# CITY OF NEWTON, MASSACHUSETTS

**To:** Zoning Board of Appeals Members  
**From:** Brenda Belsanti  
**Date:** April 30, 2024  
**Subject:** Materials for **May 1, 2024** Public Hearing

April 4, 2024

I have reviewed the revised revised civil engineering Site Plans by Bohler Engineering, Revision 3 dated February 12, 2024 and Revision 4 dated April 1, 2024 and Drainage Reports prepared by Bohler Engineering dated February 20 and April 1, 2024 and am providing this supplemental comment letter.

Figure 1 – Groundwater Mounding Results – Infiltration System 2P, 25-Year Storm

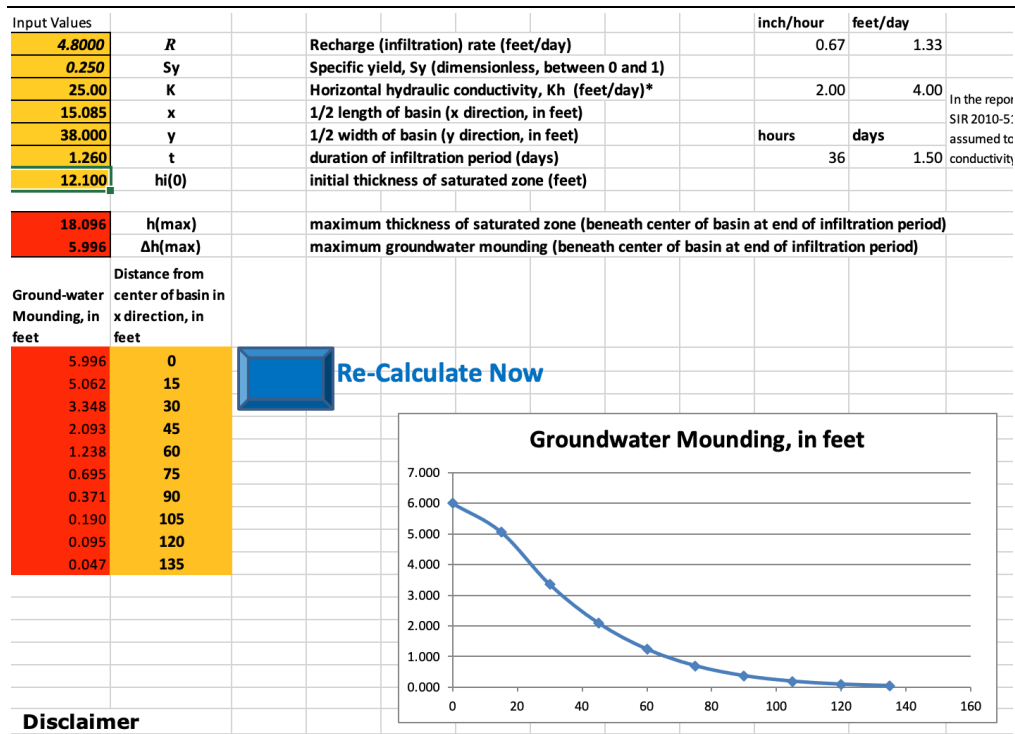
I have prepared a groundwater mounding analysis for the 25-year storm using the applicant’s input parameters (see figure 1). This analysis shows that the groundwater mound beneath the infiltration system will rise 6 feet and will inundate of the bottom of the infiltration facility and will result in additional, unaccounted for overflows that would increase off-site flooding.

The groundwater mounding analysis of the 25-year storm also shows a rise in groundwater levels of 0.7 feet (8.4 inches) at a distance of 75 feet and at the abutting property boundary. This will likely exacerbate the existing basement flooding issues at their property. The mounding analysis also indicates hydrologic impacts at the wetland boundary at a distance of approximately 100 feet.

Figure 1 – Location of Infiltration System (2P) and Test Pits

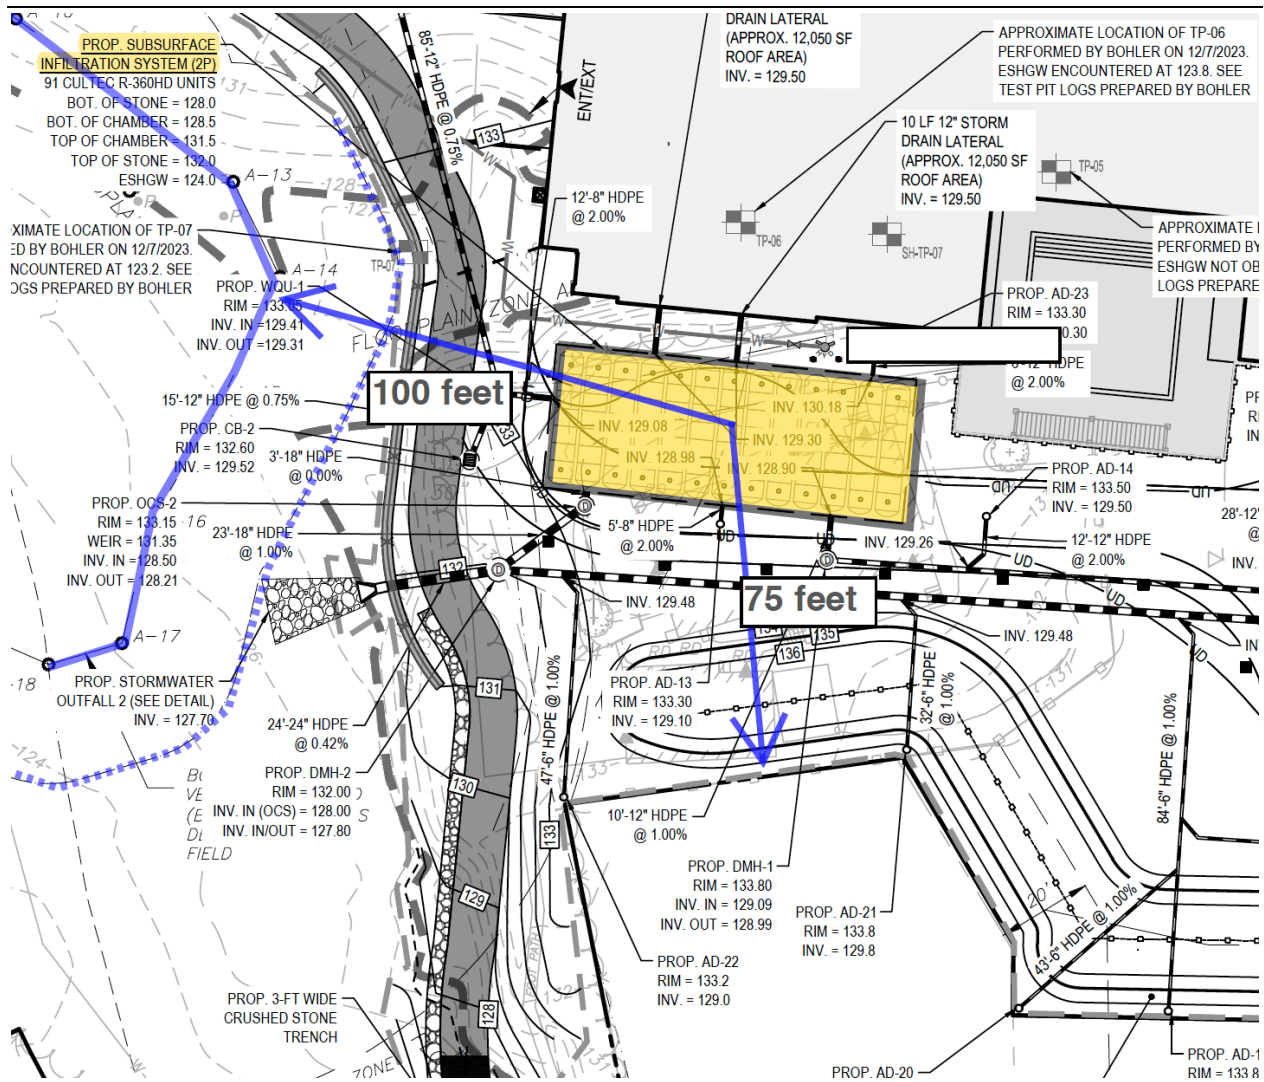
No test pits are provided within the footprint (at the actual location) of the large infiltration system (2P). Instead the proposed design relies upon test pits located to the north of the actual location (see figure 1).

Figure 1 – Groundwater Mounding Results – Infiltration System 2P, 25-Year Storm

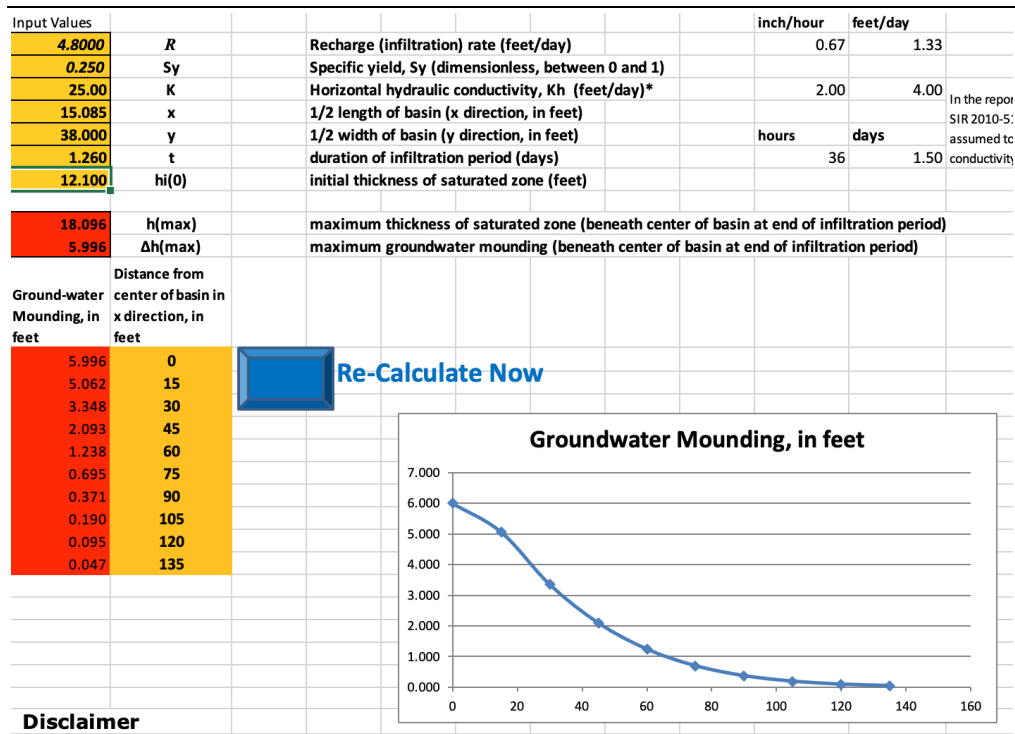
I have prepared a groundwater mounding analysis for the 25-year storm using the applicant’s input parameters (see figure 1). This analysis shows that the groundwater mound beneath the infiltration system will rise 6 feet and will inundate of the bottom of the infiltration facility and will result in additional, unaccounted for overflows that would increase off-site flooding.

The groundwater mounding analysis of the 25-year storm also shows a rise in groundwater levels of 0.7 feet (8.4 inches) at a distance of 75 feet and at the abutting property boundary. This will likely exacerbate the existing basement flooding issues at their property. The mounding analysis also indicates hydrologic impacts at the wetland boundary at a distance of approximately 100 feet.

Figure 2 – Water Budget for Charles River Watershed (USGS)

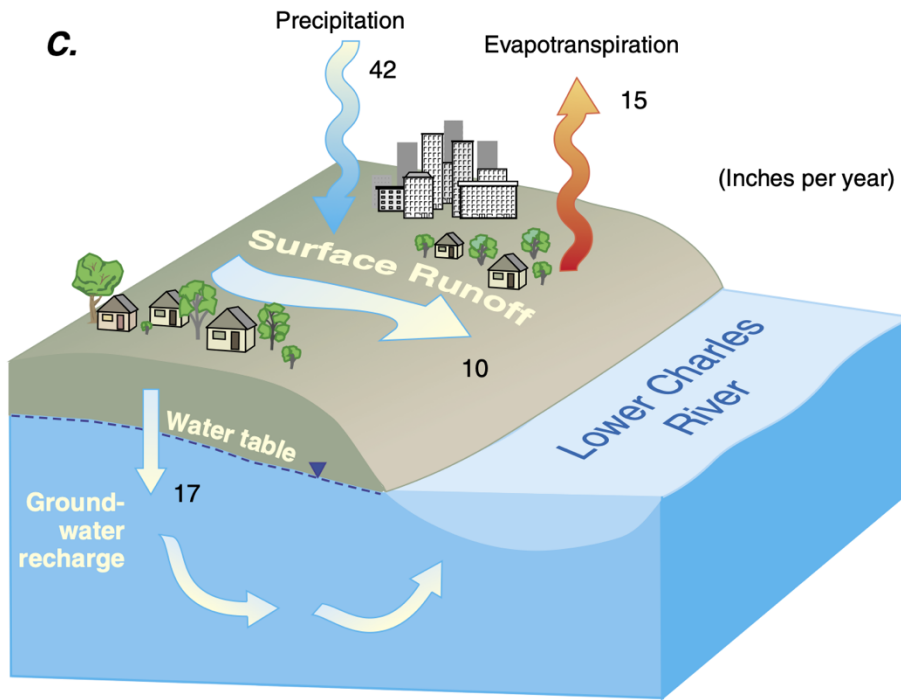
Figure 2 shows a simplified water budget prepared by the United States Geological Survey (USGS) for the lower Charles River watershed which includes Newton. This budget indicates that approximately 36% of precipitation (42 inches/year) is returned to the atmosphere as evapotranspiration (15 inches/year). The remaining (net precipitation) is partitioned between

surface runoff (10 inches/year) and groundwater recharge (17 inches/year). This budget is representative of existing conditions on the project site.

The proposed project will remove the majority of upland vegetation on the site and replace it with impervious surfaces (see figure 4). This will result in a significant reduction in ET and a corresponding increase in stormwater runoff/recharge. It is reasonable to assume that approximately 90% of the annual precipitation falling on impervious surfaces will be directed to the proposed stormwater infiltration facilities resulting in a net increase in groundwater recharge rates<sup>2</sup>. Assuming an annual precipitation rate of 42 inches/year the recharge rate associated with impervious surfaces can be estimated at 38 inches/year. This is significantly higher (more than double) the estimated existing groundwater recharge rate of 17 inches/year.
